GE Hitachi Nuclear Energy

MFN 09-391

Subject: **Response to Portion of NRC RAI Letter No. 323 Related to ESBWR Design Certification Application – DCD Tier 2 Section 3.7 – Seismic Design; RAI Numbers 3.7-69 thru 3.7-72**

DCD Tier 2 Section 3.7 – Seismic Design

**Figure 3.7-72(1) Comparison of FRS by SASSI and DAC3N
- Hard Site, CB Top, X-Direction -**

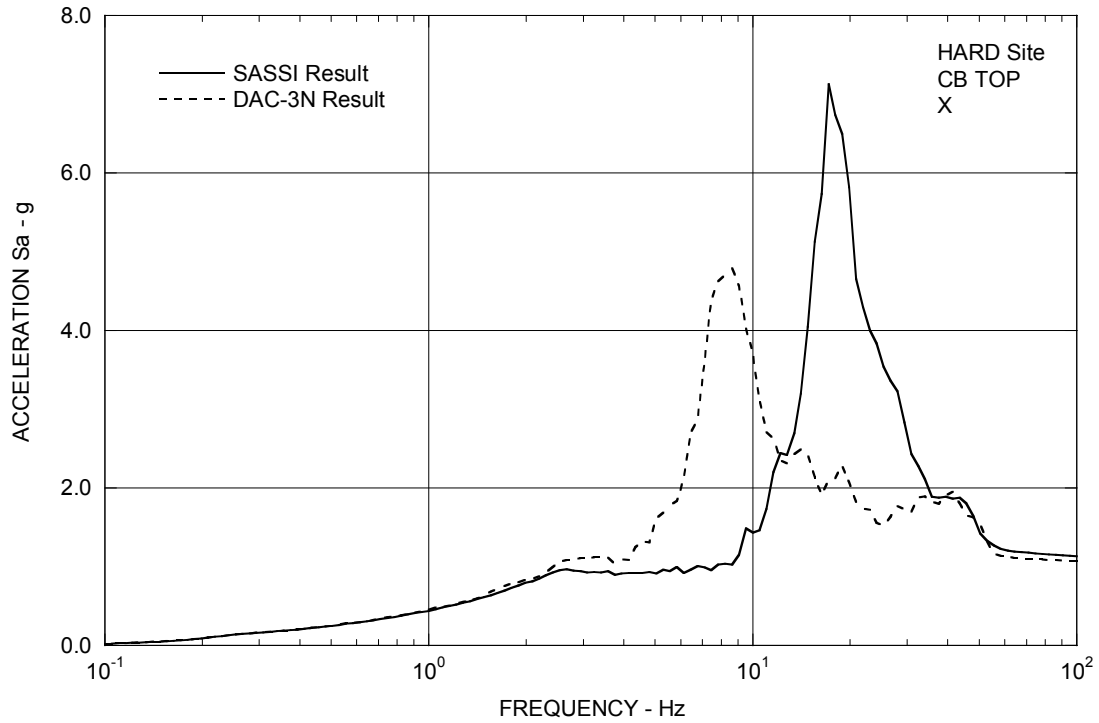
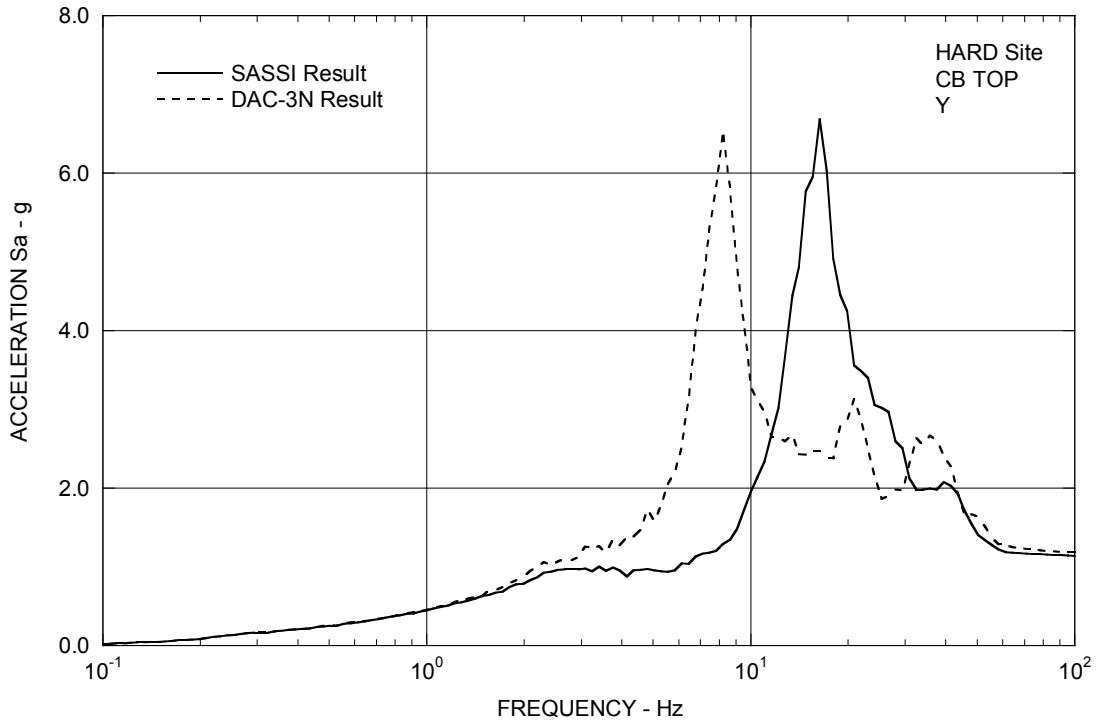
GEH states in the DCD, through Rev. 5, and in prior RAI responses, that ignoring embedment effects is conservative. Conceptually, the staff concurred with this. Therefore, the finding that in-structure response spectra generated at the top of the CB using the new SASSI analysis results for uniform sites with embedment significantly exceed the DAC-3N analysis results for uniform sites without embedment requires further evaluation. The staff reviewed the new response spectra comparisons included in the response to RAI 3.8-94, and noted that the significant exceedances are in the 2 horizontal directions, at about 15 Hz, for the hard uniform site.

- (1) To better characterize these results and understand this behavior, the staff requests GEH to provide separate one-to-one comparisons between DAC-3N results and SASSI results for (1) each of the 3 uniform site cases (soft, medium, hard), (2) for each direction (X,Y,Z), and (3) for the CB Top and the CB Basemat, a total of 18 comparisons.*
- (2) The staff also requests GEH to evaluate whether each “with embedment” exceedance can be explained on physical grounds, or if it is potentially an indication of a modeling or numerical error.*

- (1) Separate one-to-one comparisons of floor response spectra between DAC3N results and SASSI results for (1) each of the 3 uniform site cases (soft, medium, hard), (2) for each direction (X,Y,Z), and (3) for the CB Top and the CB Basemat are shown in Figures 3.7-72(1) through 3.7-72(18).

The DAC3N floor response spectra at the CB Basemat envelop the SASSI floor response spectra due to the embedment effect. At the CB Top for the hard site case, the spectral peak frequencies of the SASSI floor response spectra in the horizontal directions (X,Y) shift from a peak frequency of approximately 8.5 Hz for the DAC3N results to a peak frequency of approximately 17 Hz for the SASSI results. At the CB Top for the hard site case, the spectral peak frequency of the SASSI floor response spectra in the vertical direction (Z) shifts from a peak frequency of approximately 21 Hz for the DAC3N results to a peak frequency of approximately 28 Hz for the SASSI results. This frequency shift is attributed to the constraining effect of the surrounding soil.

The embedment effect on the CB response is pronounced because a large portion (62%) of the building is embedded. As a result, the entire SSI system is much more rigid when embedment is taken into account.
